PARK DEPARTMENT
TRAFFIC DIVISION
CHIEF P. W. ENGR.
APPROVED BY
DIRECTOR OF PUBLIC WORKS
DATE 11/10/69
STEARNS STREET STORM DRAIN
STEARNS TO CORRELL AT UPRR AND LOT 44
HORIZ. SCALE: 1" = 40' VERT. SCALE: 1" = 2'
PROJECT NO. 431
D-193

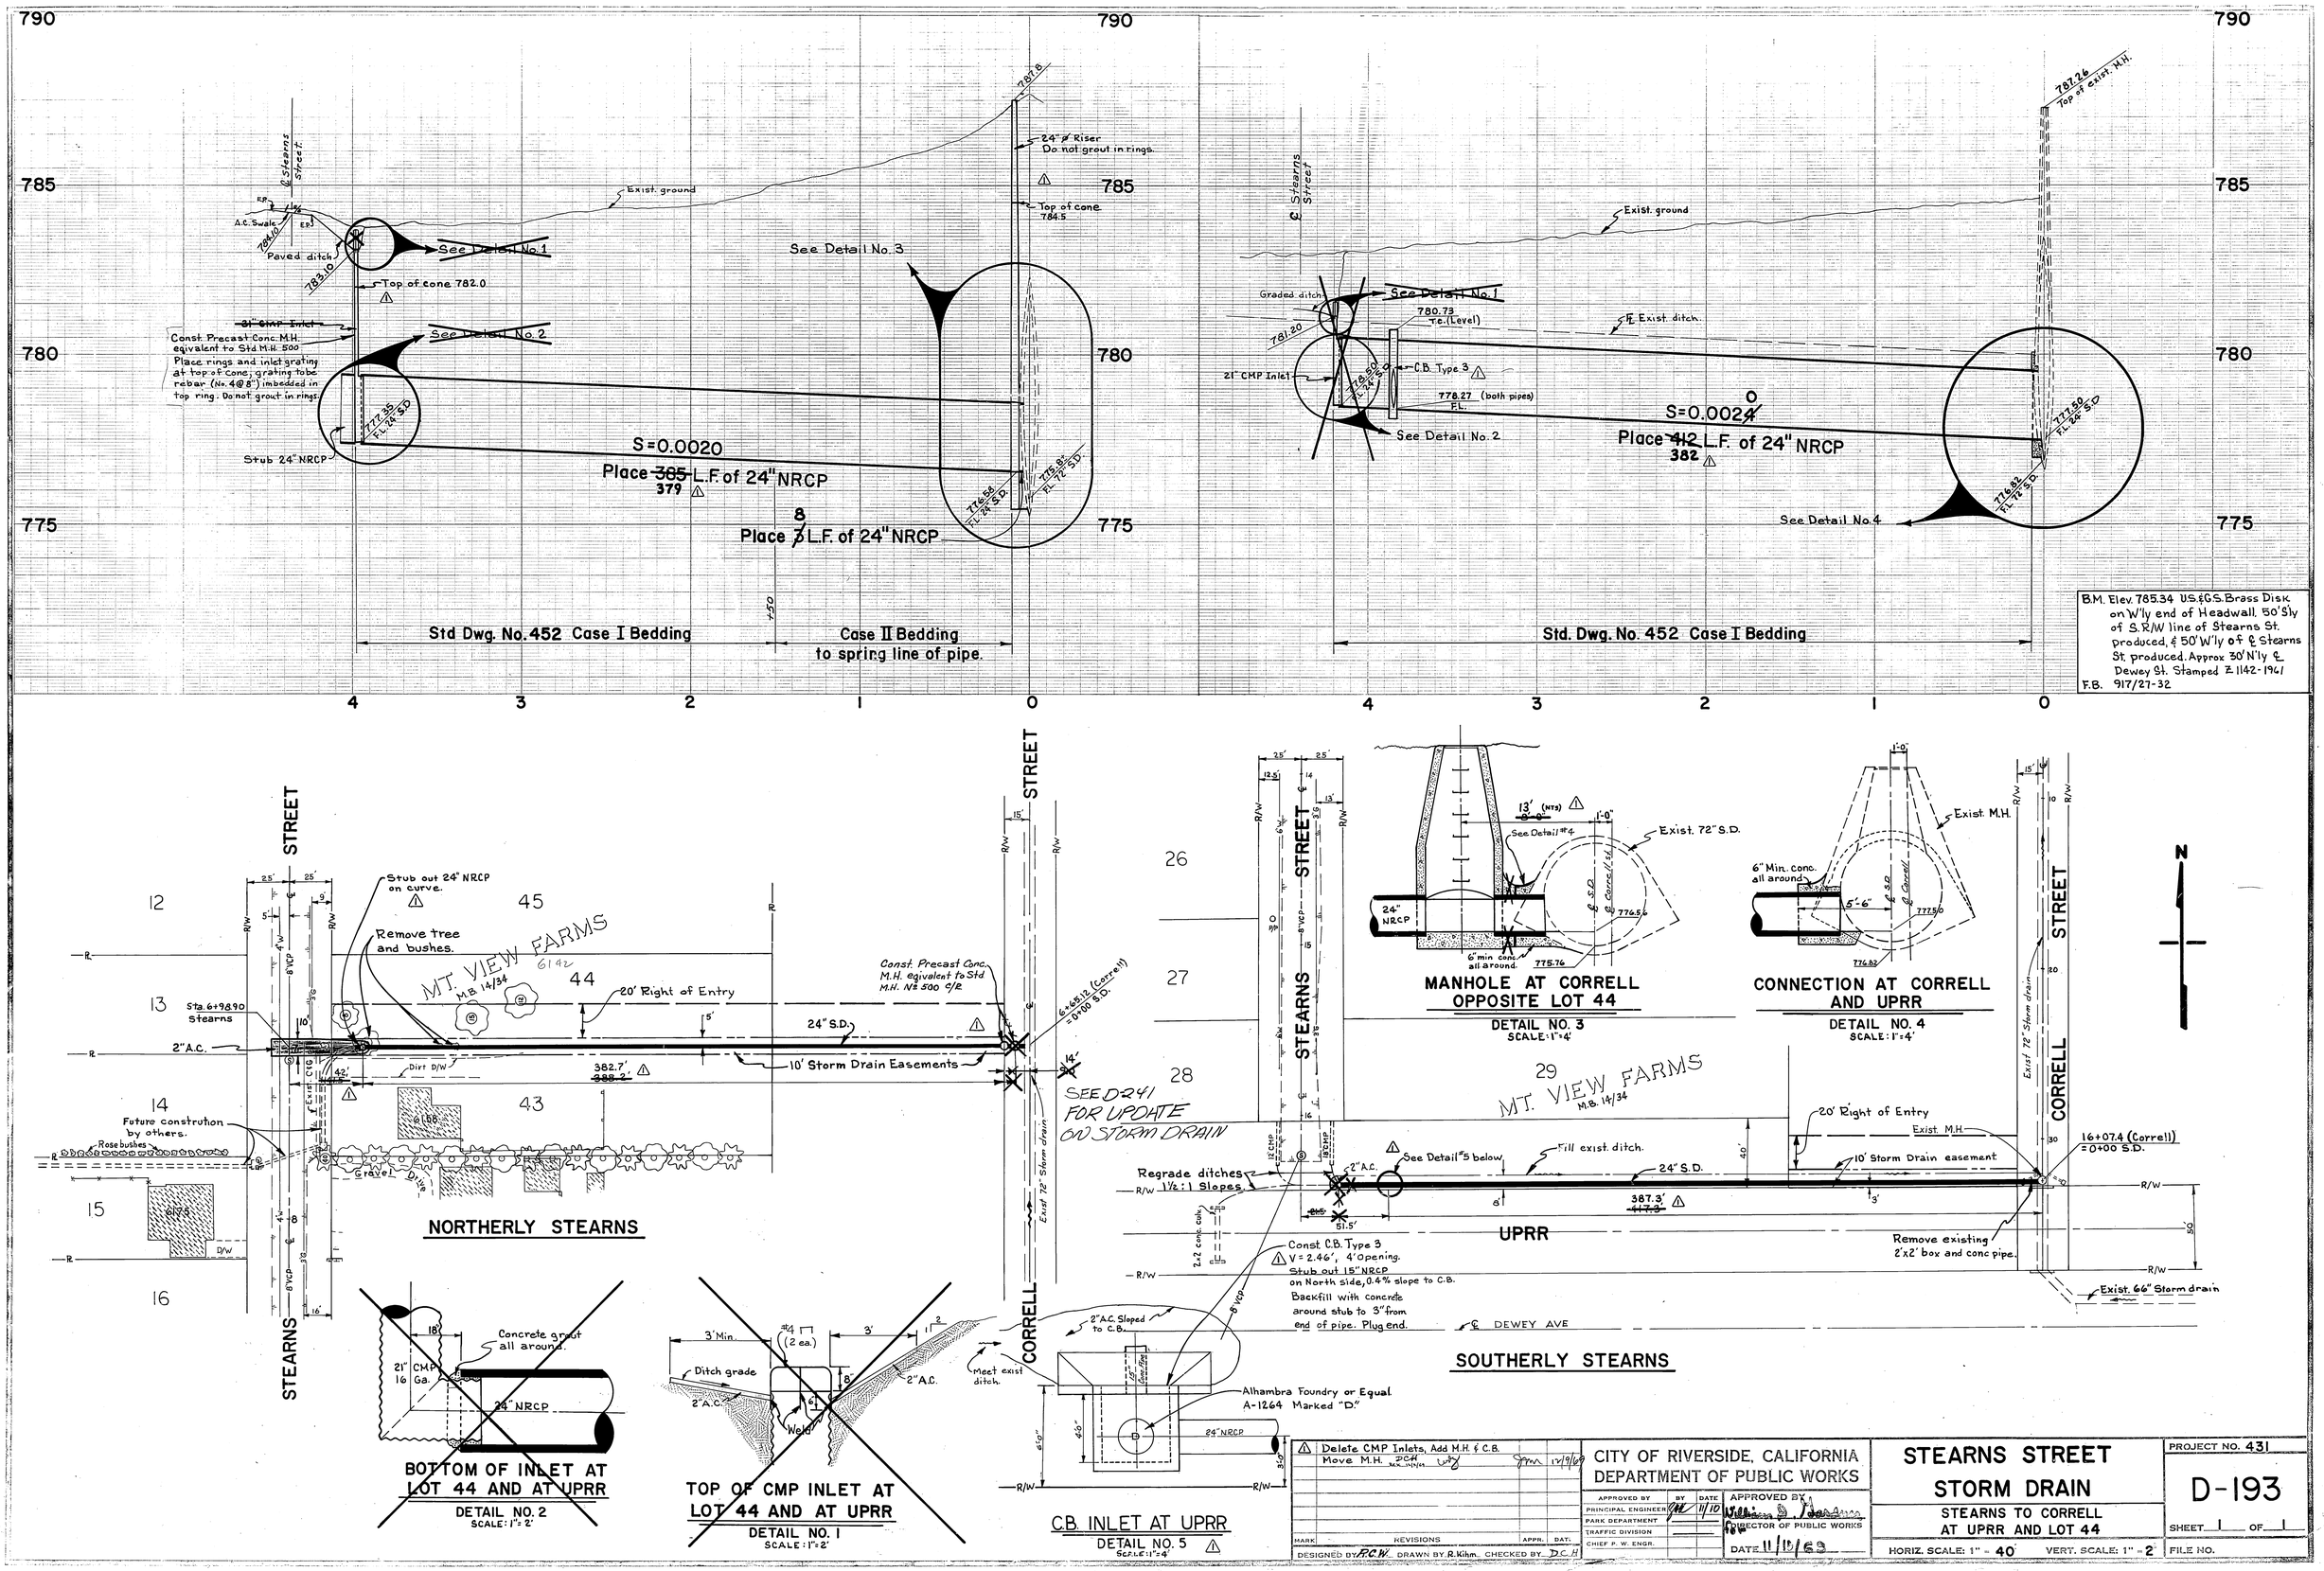
772.35 F.L. 24" S.D.
Exist. ground
787.8
24" ø Riser Do not grout in rings.
Top of cone 784.5
See Detail No. 3
S=0.0020
Place ~~385~~ 379 L.F. of 24" NRCP
775.85 F.L. 72" S.D.

781.20
21" CMP Inlet
C.B. Type 3
778.27 (both pipes) F.L.
See Detail No. 2
Exist. ditch
S=0.0024
Place ~~412~~ 382 L.F. of 24" NRCP
787.26 Top of exist. M.H.
777.50 F.L. 24" S.D.

382.7' ~~388.2'~~
Dirt D/W
Future constrution by others.
Rose bushes
Gravel D/W
6175
Const. Precast Conc. M.H. equivalent to Std M.H. 500 S/E
6+45.12 (Correll) = 0+00 S.D.
SEE D241 FOR UPDATE ON STORM DRAIN
Exist. 72" Storm drain
NORTHERLY STEARNS
26
27
28
29
MT. VIEW FARMS
M.B. 14/34
See Detail #4
Exist. 72" S.D.
24" NRCP
6" min. conc. all around.

387.3' ~~417.8'~~
UPRR
20' Right of Entry
Exist. M.H.
10' Storm Drain easement
16+07.4 (Correll) = 0+00 S.D.
Remove existing 2'x2' box and conc pipe.
Exist. 66" Storm drain
Const. C.B. Type 3
V = 2.46', 4' Opening.
Stub out 15" NRCP on North side, 0.4% slope to C.B.
Backfill with concrete around stub to 3" from end of pipe. Plug end.
℄ DEWEY AVE
SOUTHERLY STEARNS
N
Concrete grout all around.
21" CMP 16 Ga.
24" NRCP
BOTTOM OF INLET AT LOT 44 AND AT UPRR
DETAIL NO. 2
SCALE: 1"= 2'
3' Min.
(2 ea.)
Ditch grade
2" A.C.
Weld
Meet exist ditch.
TOP OF CMP INLET AT LOT 44 AND AT UPRR
DETAIL NO. 1
SCALE: 1"=2'
2" A.C. Sloped to C.B.
Alhambra Foundry or Equal A-1264 Marked "D"
24" NRCP
C.B. INLET AT UPRR
DETAIL NO. 5
SCALE: 1"=4'
Delete CMP Inlets, Add M.H. & C.B.
Move M.H.
MARK REVISIONS APPR. DATE
DESIGNED BY R.C.W. DRAWN BY R. Kihm CHECKED BY D.C.H.
CITY OF RIVERSIDE, CALIFORNIA
DEPARTMENT OF PUBLIC WORKS
APPROVED BY BY DATE
PRINCIPAL ENGINEER
